DOCKETED	
Docket Number:	23-AFC-02
Project Title:	Elmore North Geothermal Project (ENGP)
TN #:	258976
Document Title:	Elmore North Geothermal LLC Comments on the Preliminary Staff Assessment
Description:	N/A
Filer:	Jerry Salamy
Organization:	Jacobs
Submitter Role:	Applicant Consultant
Submission Date:	9/4/2024 3:41:55 PM
Docketed Date:	9/4/2024

Elmore North Geothermal Project (23-AFC-02) Preliminary Staff Assessment Comments

Prepared by
Elmore North Geothermal LLC

September 4, 2024

Figure 5.2-1R
Land Cover and Vegetation Types
Elmore North Geothermal Project
Imperial County, California

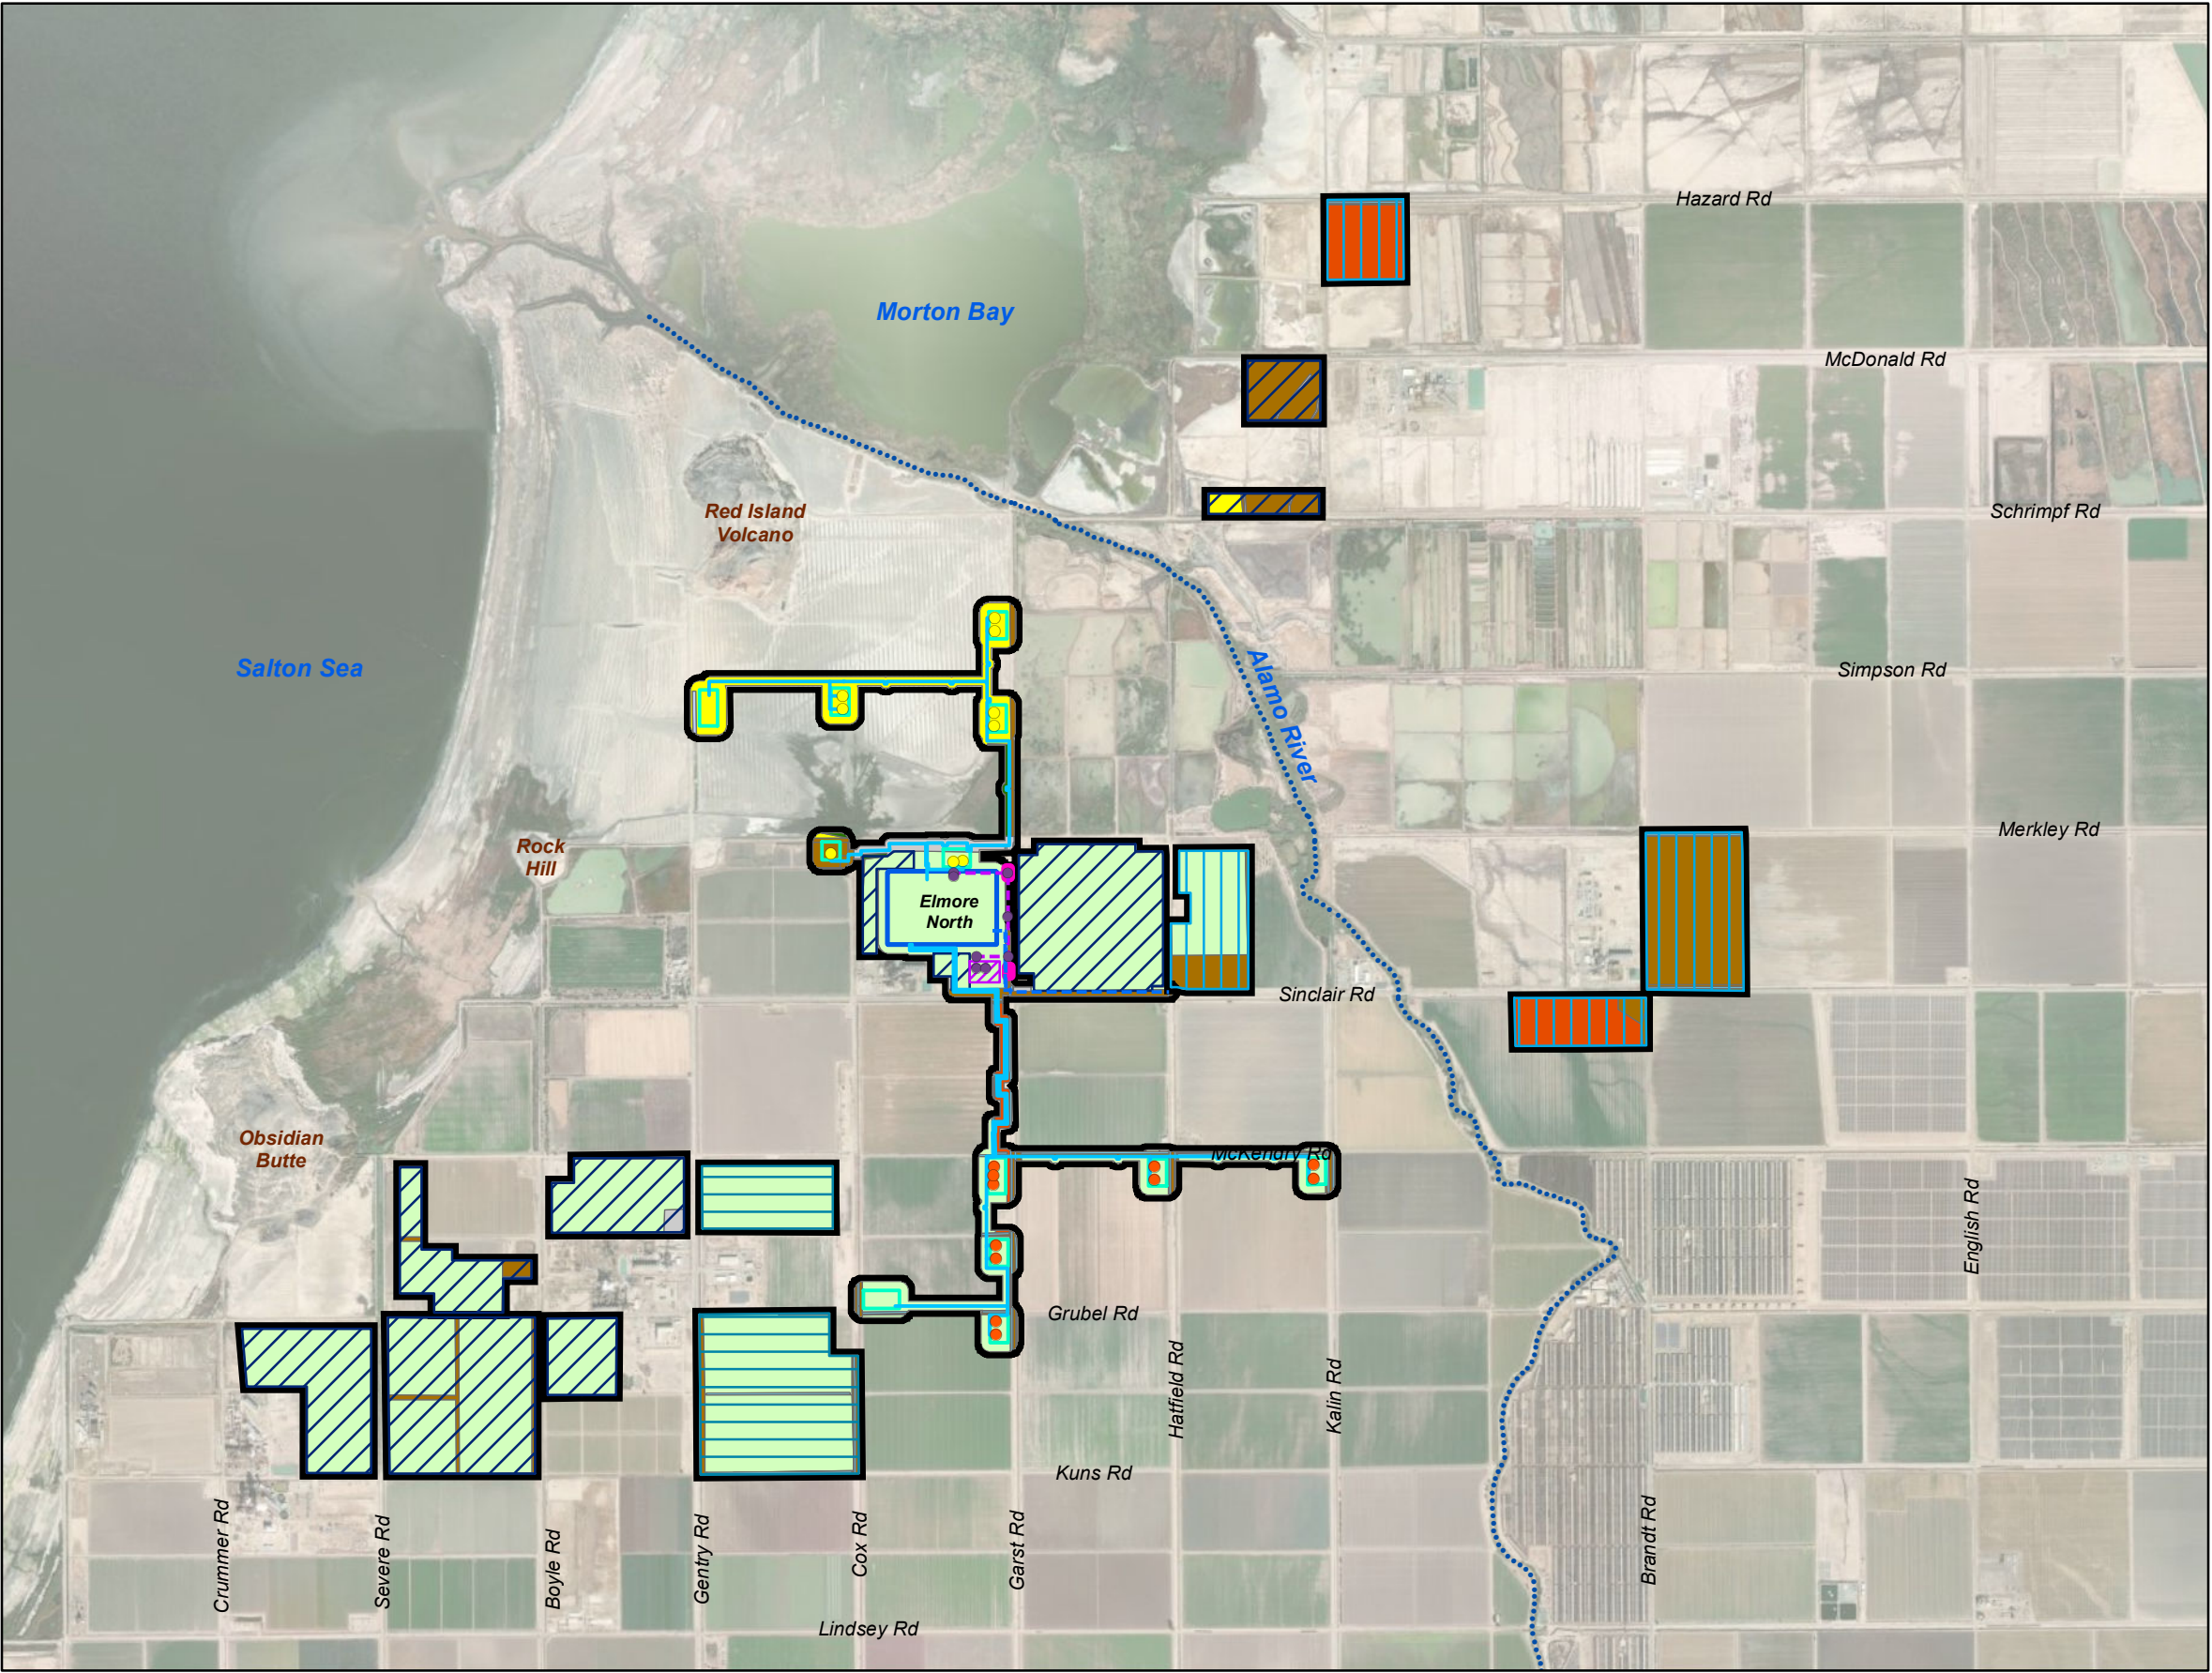
Pages 5.2-38, Table 5.2-2 – The project does not contain suitable cottonwood or dense tamarisk nesting habitat for southwestern willow flycatcher (see updated **Figure 5.2-1R** and revised **Table 5.2-5** for current vegetation and land cover types within the project area). Southwestern willow flycatcher were not listed on the IPaC generated March 28, 2023. Although the adjacent SBSSNWR has riparian and wetland habitats, Southwestern willow flycatcher is not included on SBSSNWR Wildlife List (USFWS 2018). This species is not expected to nest or forage in the project area. This species could be present rarely during migration.

Pages 5.2-127 through 5.2-128 – Revised Table 5.2-5 reflects current vegetation and land cover impacts of the project while removing overlapping features. Desert Holly Scrub has been removed as this vegetation type is only in the 1-mile buffer of the project on Red Island Volcano.
